ADDENDUM NUMBER THREE

**USC Health Sciences Renovation
Project No.: U-676-09**

State Permanent Improvement Project No.: H27-6052-AC

DATE OF ISSUE: November 7, 2013

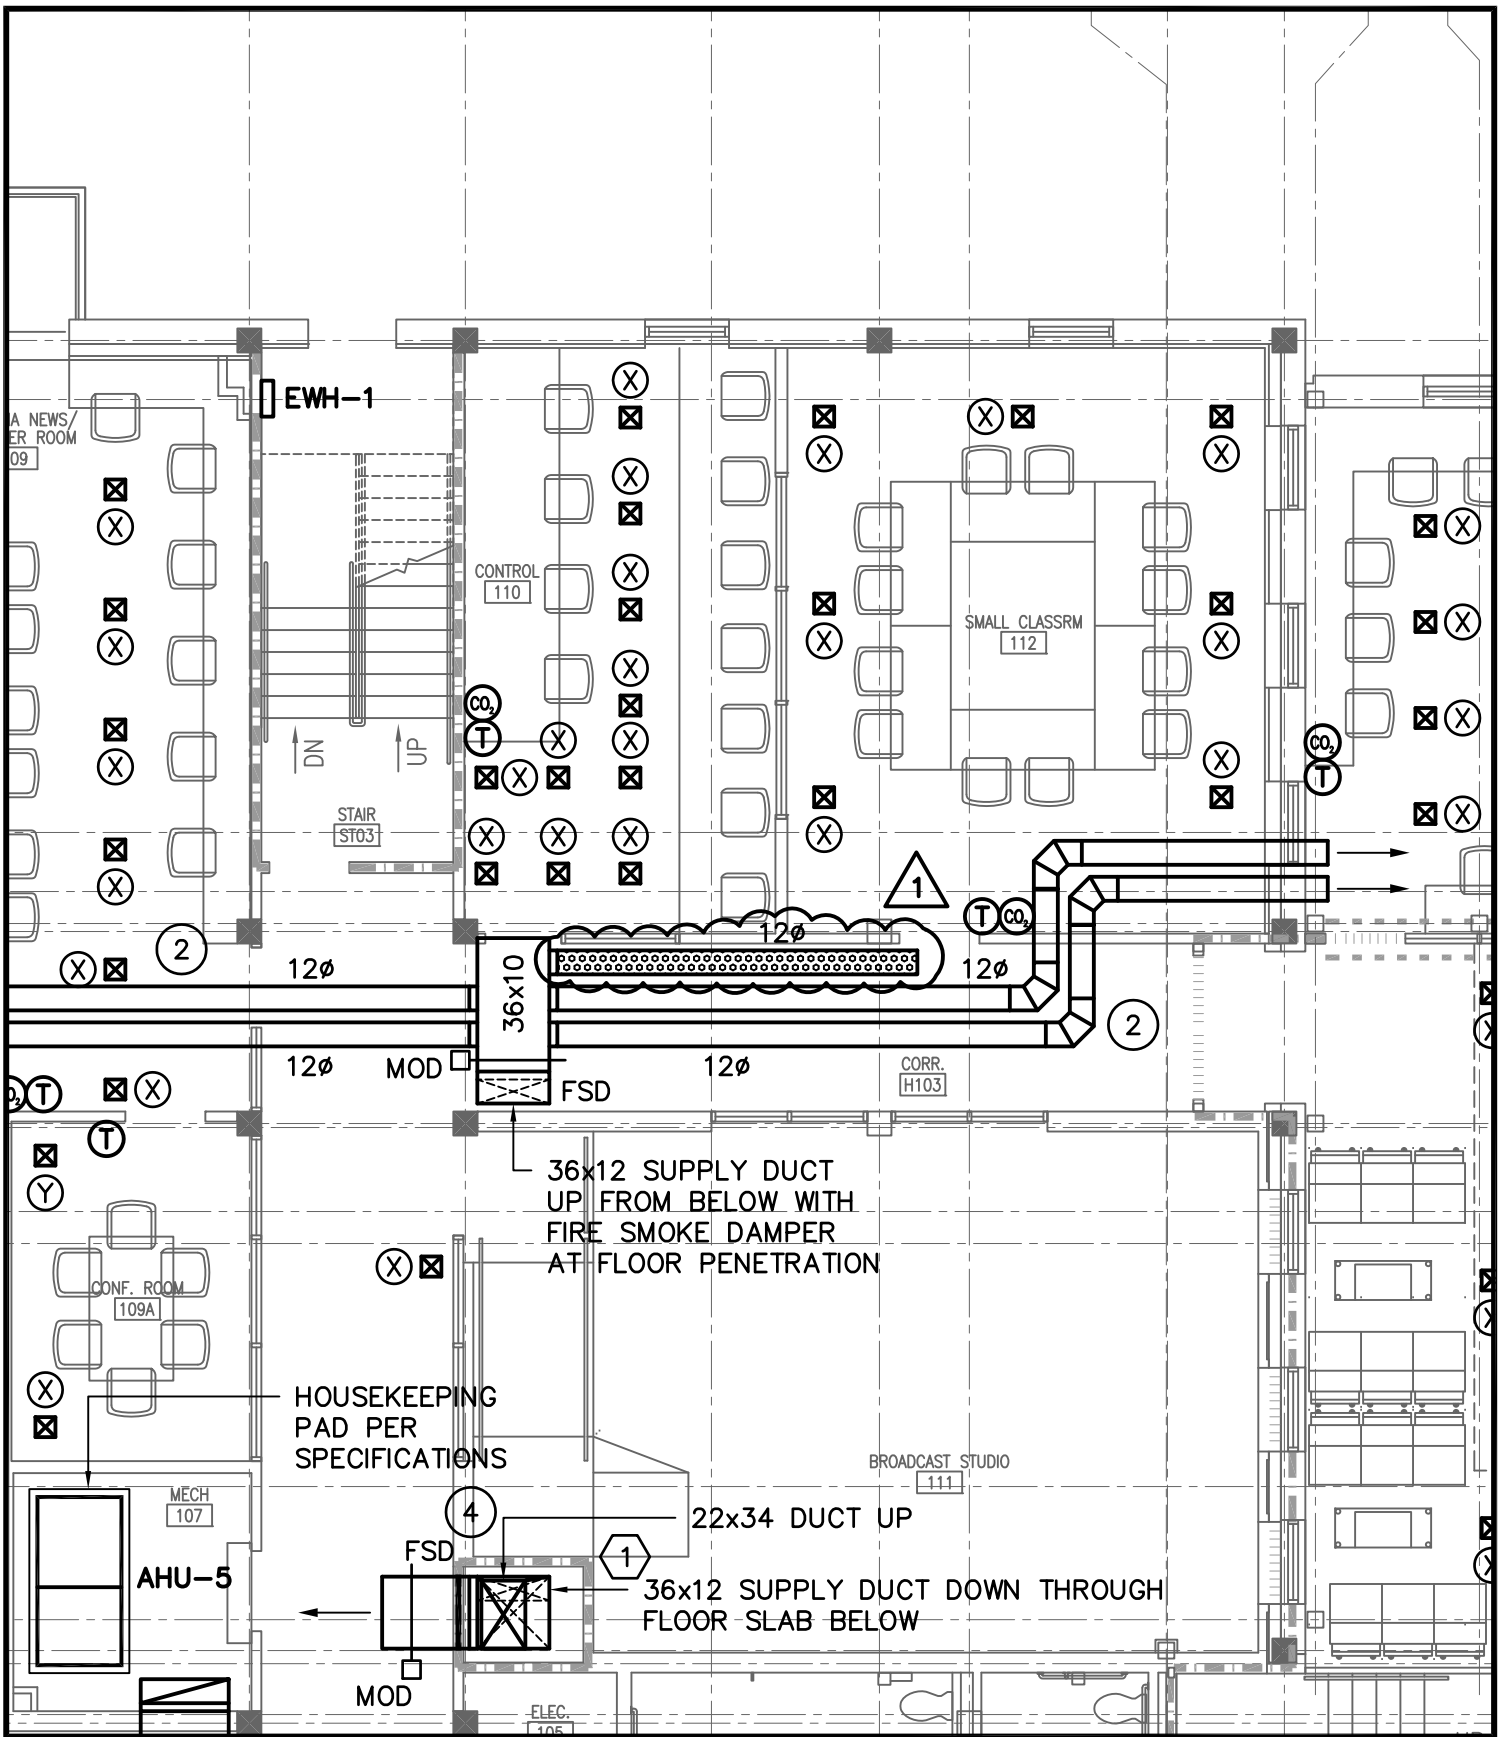
11. Revision: Reference Drawing M1.1A First Floor Underfloor Plan. See attached sketch SK-M1. This sketch modifies the underfloor duct at Control Room 110.

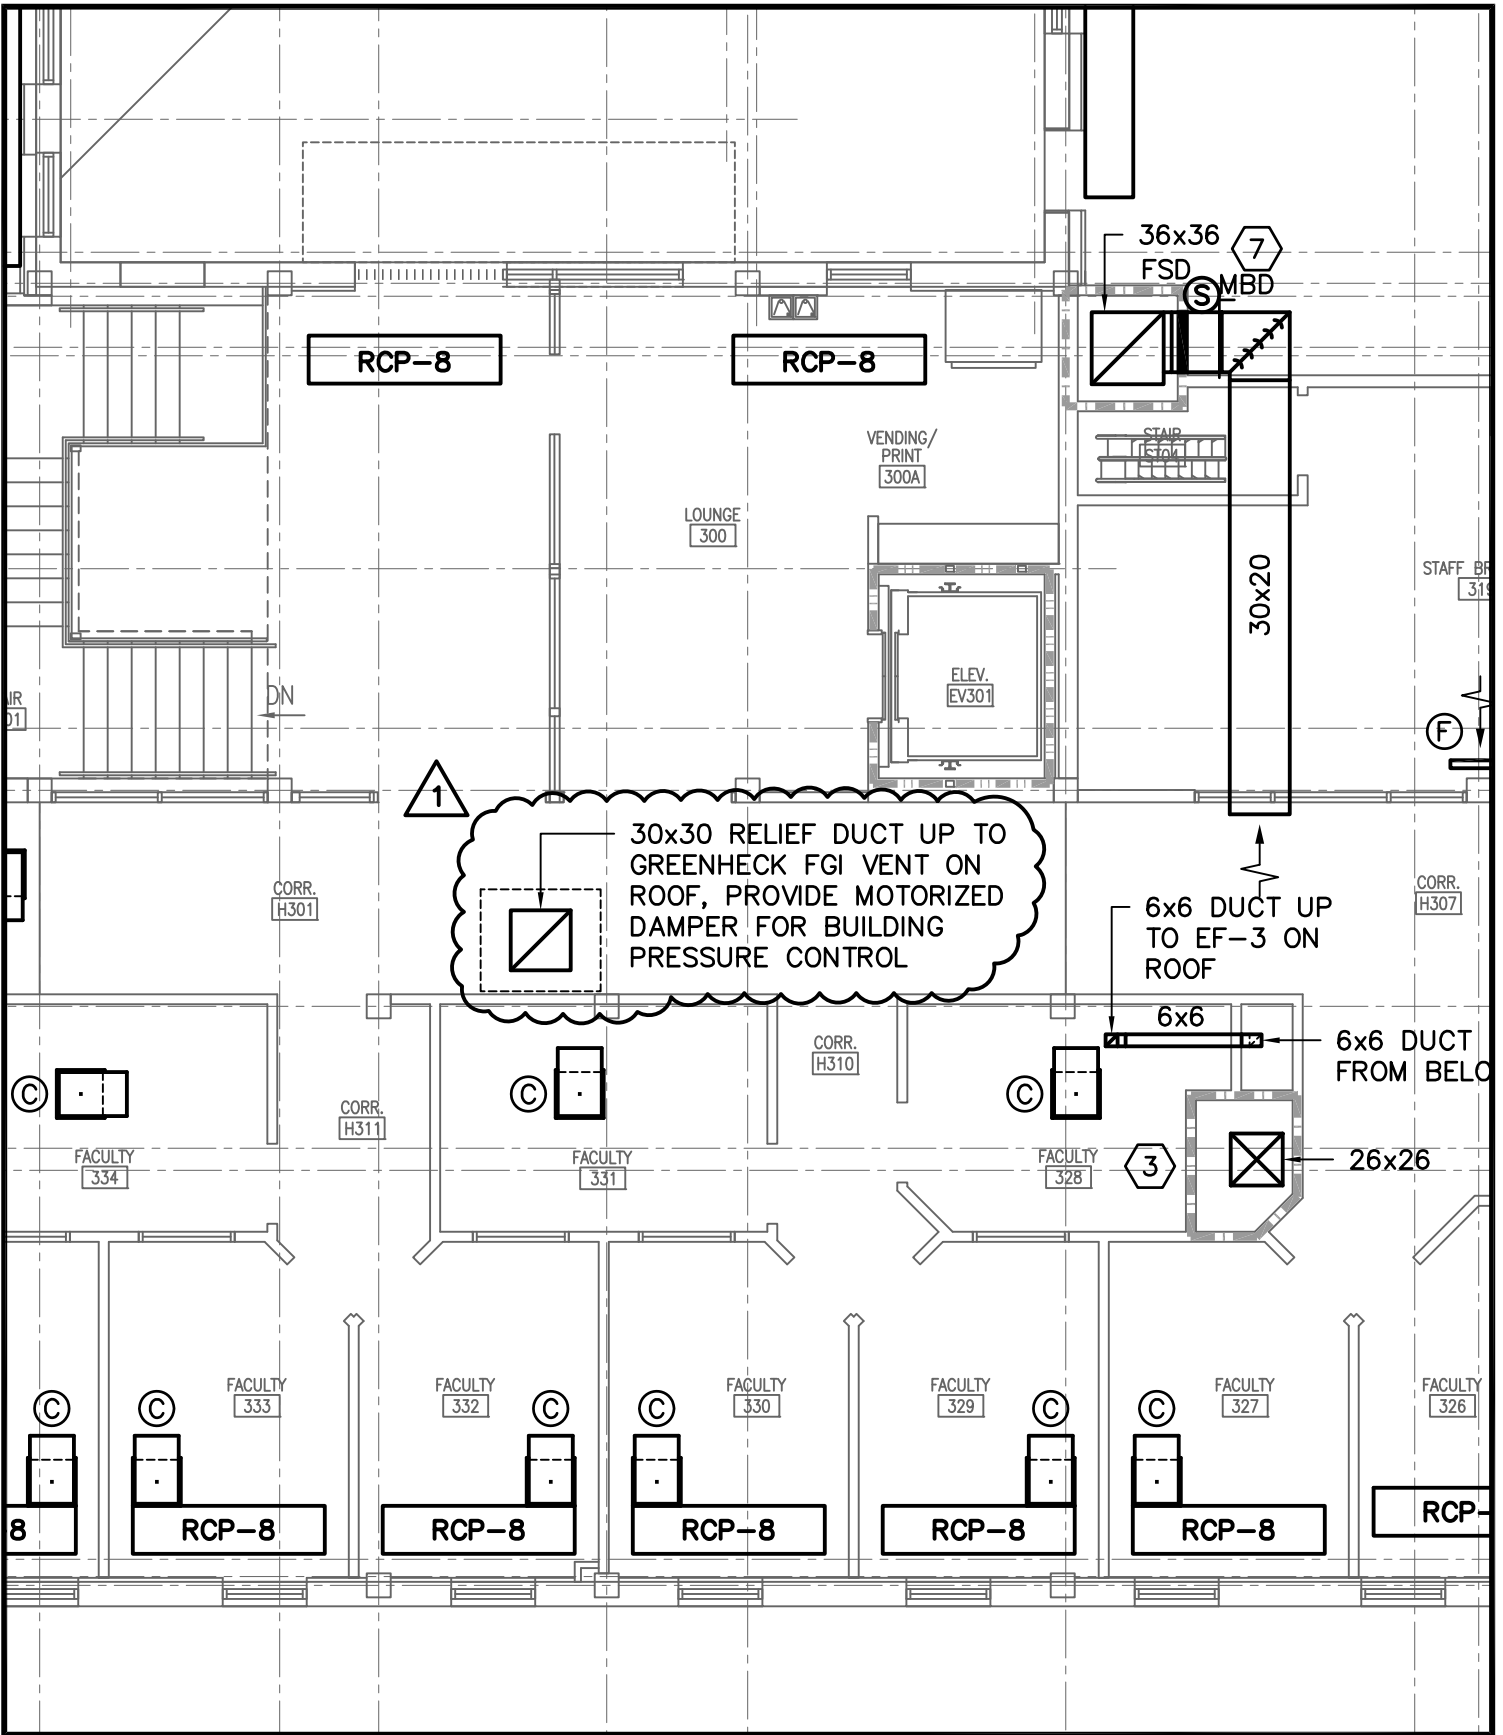
12. Revision: Reference Drawing M1.3B Third Floor Plan. See attached sketch SK-M2. This sketch adds a building pressure relief damper and hood on the roof.

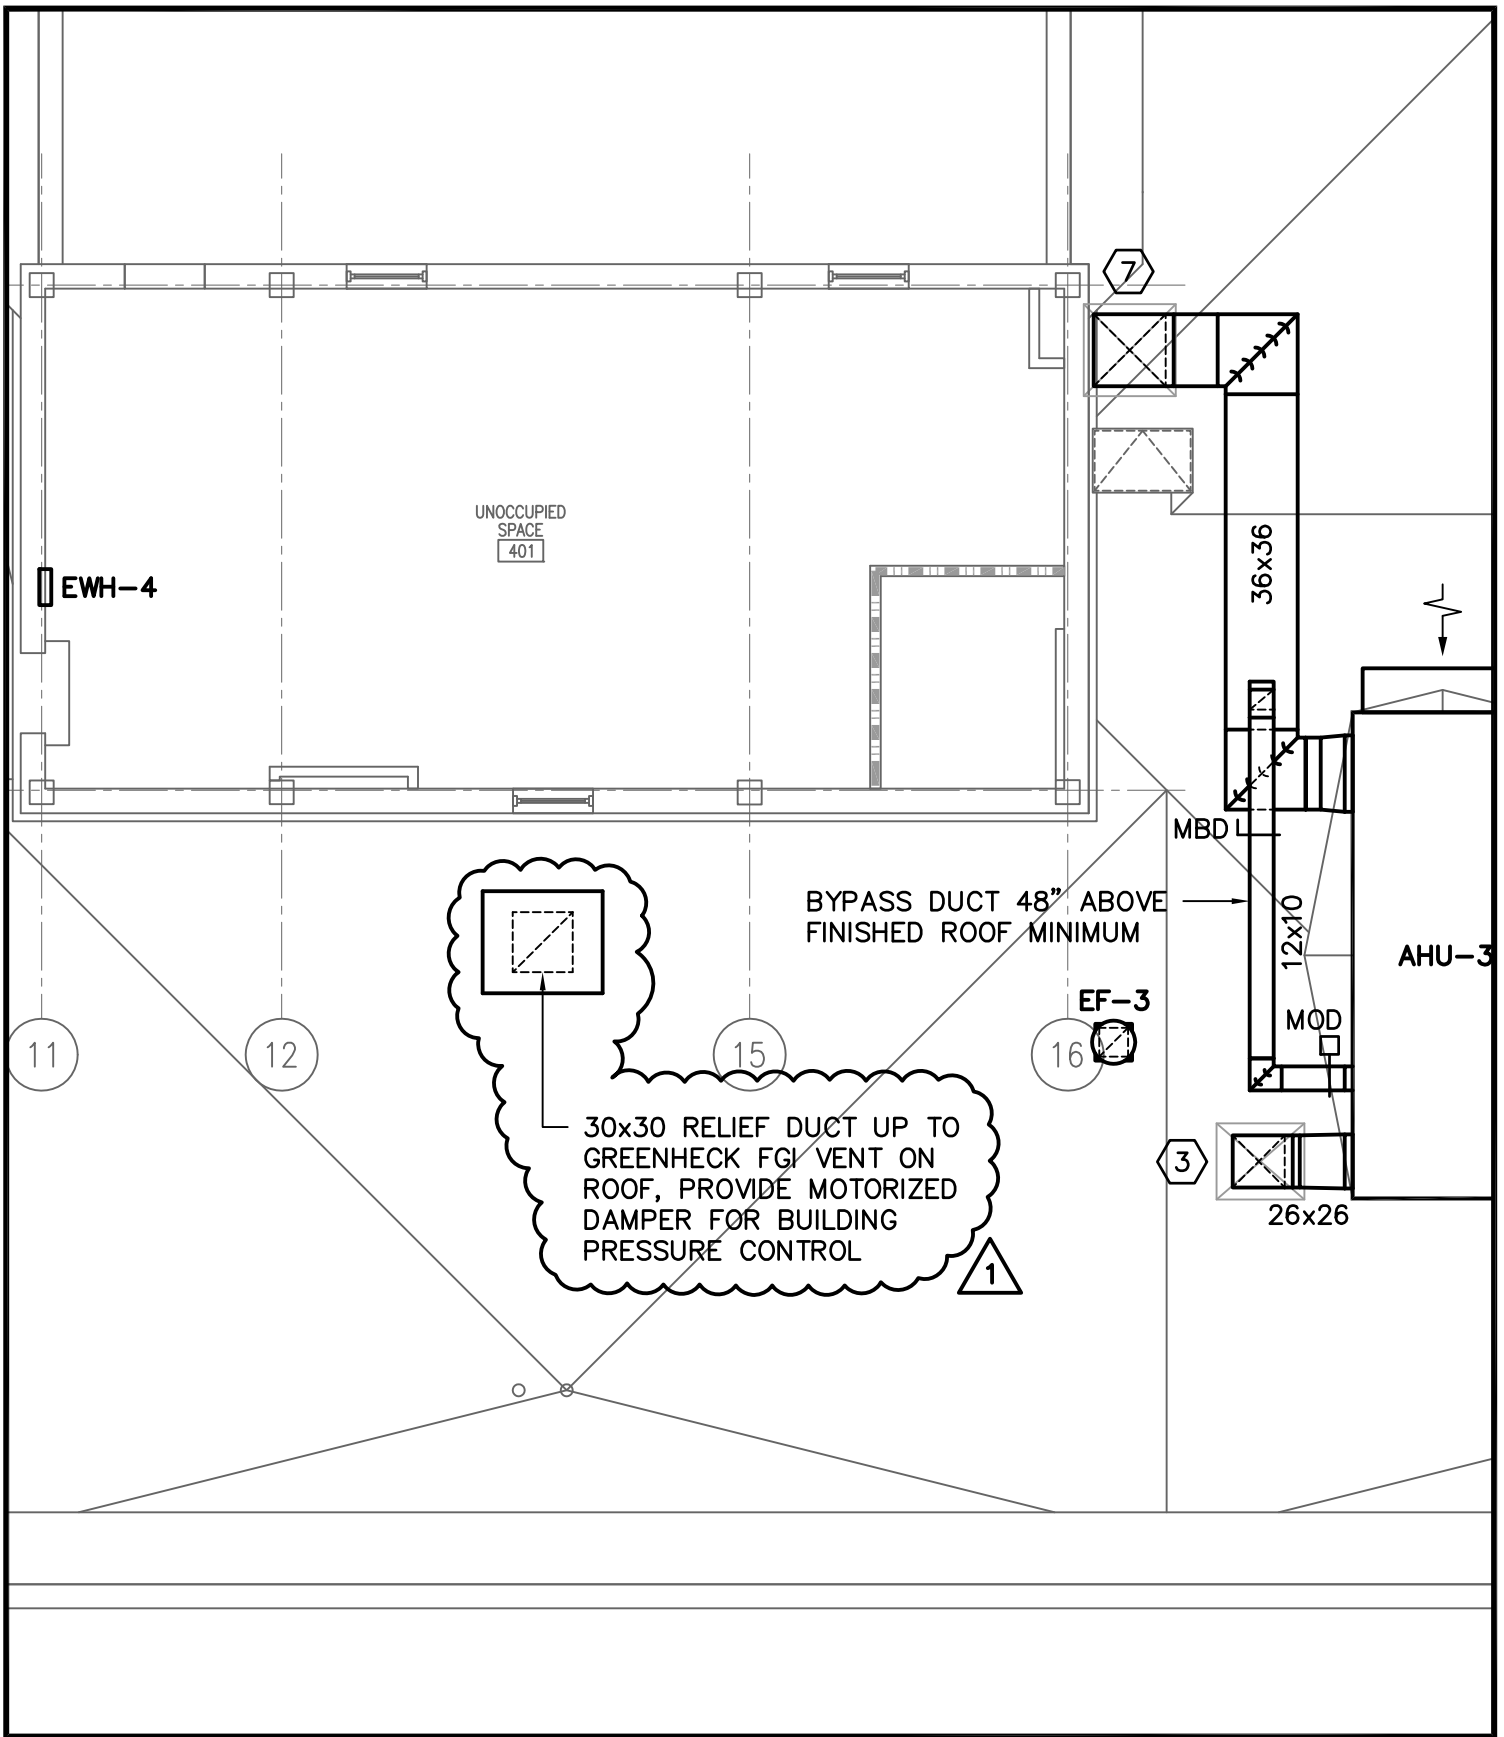
13. Revision: Reference Drawing M1.4 Roof Plan. See attached sketch SK-M3. This sketch adds a building pressure relief damper and hood on the roof.
14. Revision: Reference Drawing M3.2 Riser Schematics. This revised drawing M3.2-R1 adds CFM values to the duct risers for air balancing. Air balancing shall include AHU airflow readings for total air and ventilation air at the main unit and airflow balancing at the riser branch ducts on each floor per the riser diagrams.

1 DUCT RISER SCHEMATIC
M3.2 NO SCALE

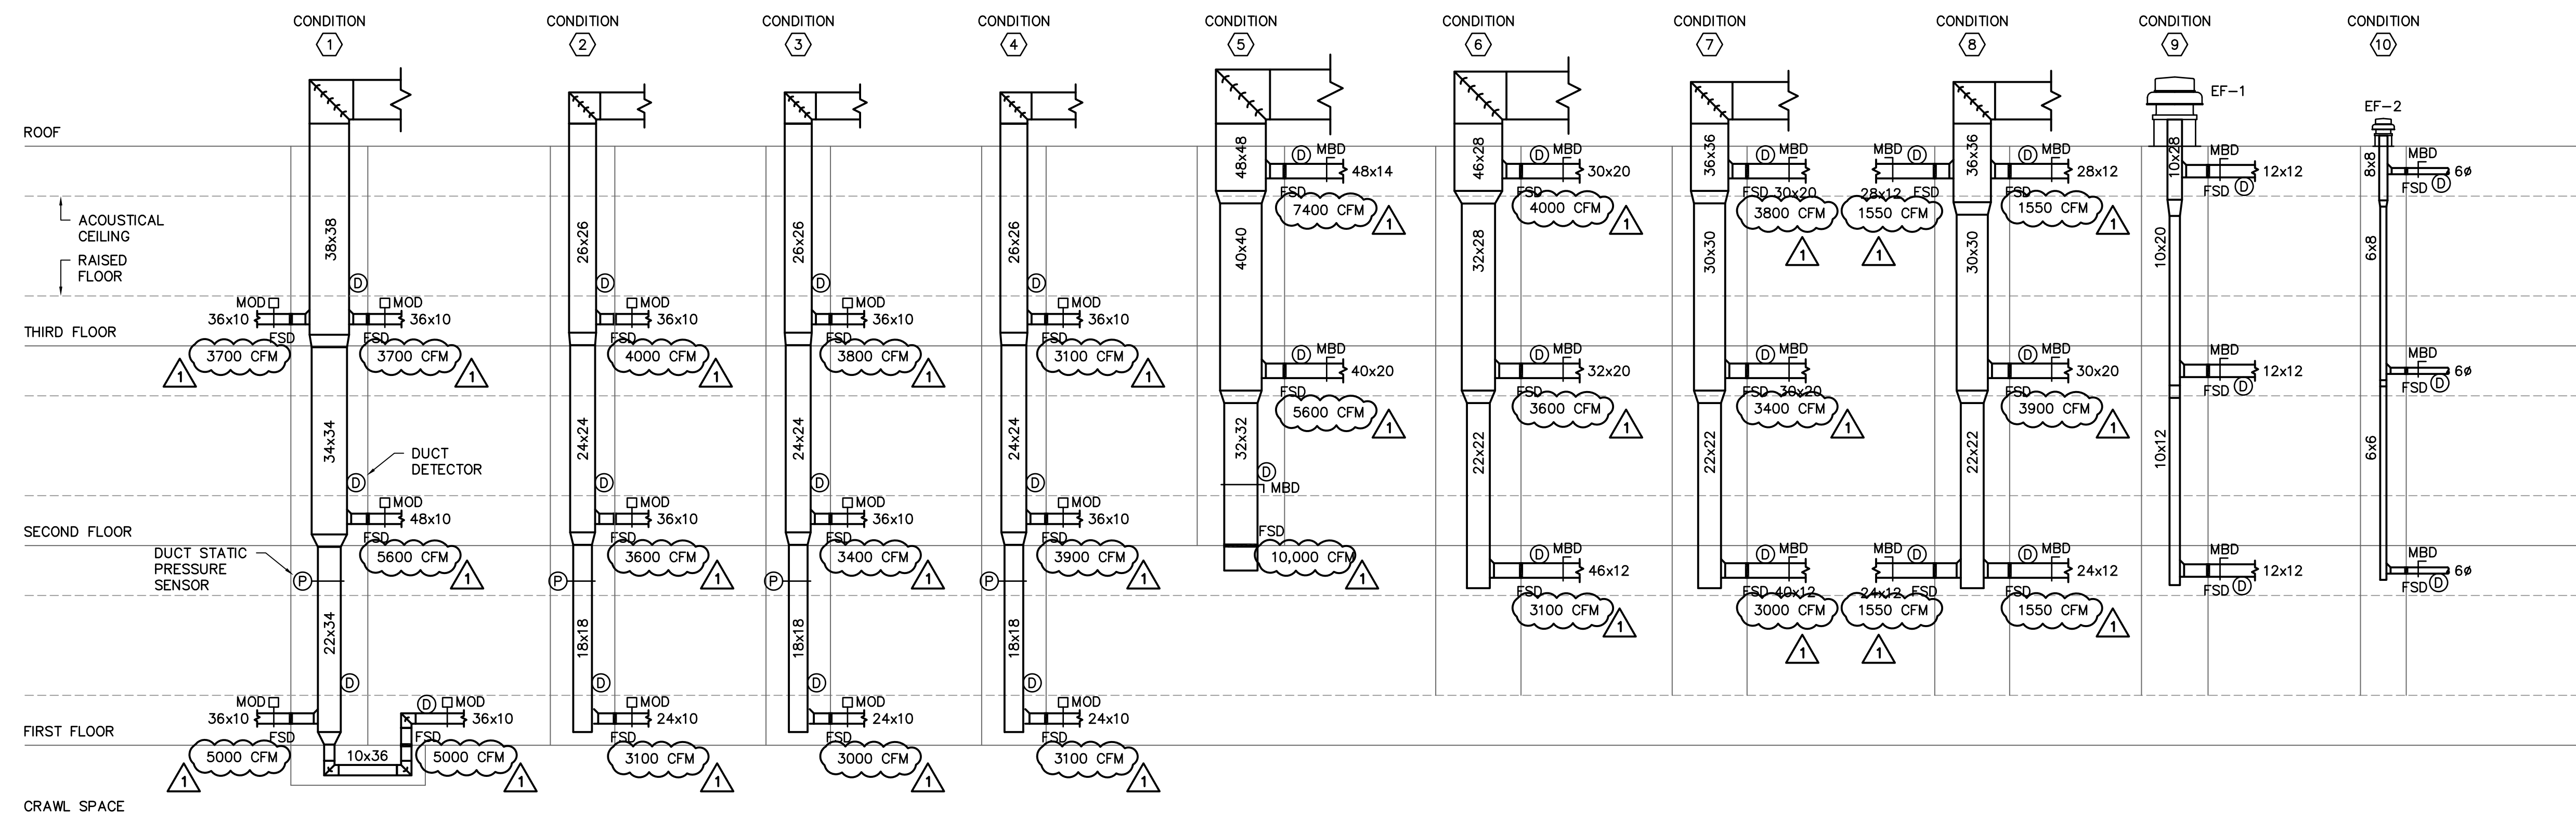
reaplace with “AHU-1, AHU-2, AHU-3 and AHU-4”. These supply and return smoke dampers are located in the shafts as shown on M3.2.
